2.0 LIMITING CONDITIONS FOR OPERATION
2.8 Refueling Operations (Continued)

DISCUSSION

These Technical Specification changes are being made to administratively support an application by the District dated March 12, 1982, to install high density spent fuel storage racks at the Fort Calhoun Station. These racks will be divided into 2 regions; Region 1, which utilizes poisons, and Region 2, which takes credit for fuel burnup to limit reactivity below a specified value. The intent of these Technical Specification changes is to:

Spent Fuel Pool Region 2 Storage Criteria
Minimum Required Fuel Assembly Exposure
as a Function of Initial Enrichment
to Permit Storage in Region 2

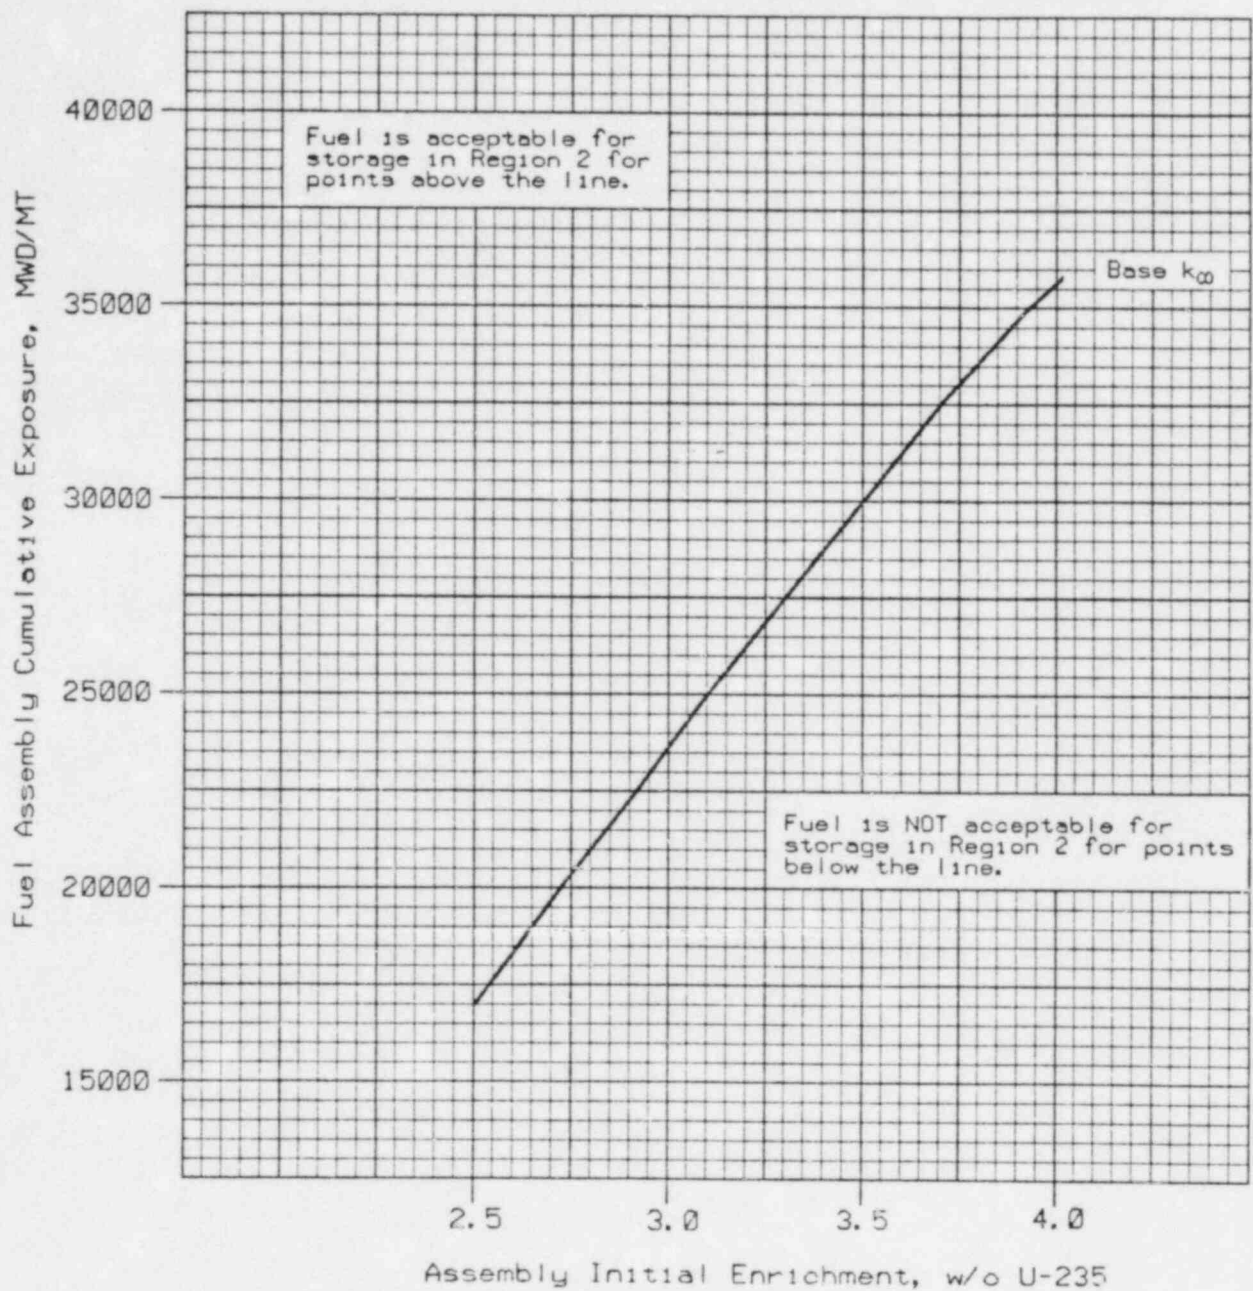
- (12) Storage in Region 2 of the spent fuel racks shall be restricted to those assemblies whose parameters fall within the "acceptable" region of Figure 2-10.

- (1) Provide an administrative control over the selection of fuel assemblies to be placed in Region 2 to assure these assemblies meet the necessary criteria for storage in that area. The acceptance criteria will be based on Figure 2-10, "Spent Fuel Pool Region 2 Storage Criteria", which will be added to the Technical Specifications by this change. Justification for this figure was presented in the January 21, 1983 submittal for the spent fuel storage rack application. The statement describing who may perform an independent review in Technical Specification 5.8.4 was based on 10 CFR 50, Appendix B, Part III (Design Control).
- (2) Provide assurance that surveillance requirements for periodic testing of neutron poison samples in the Region 1 spent fuel racks are met.
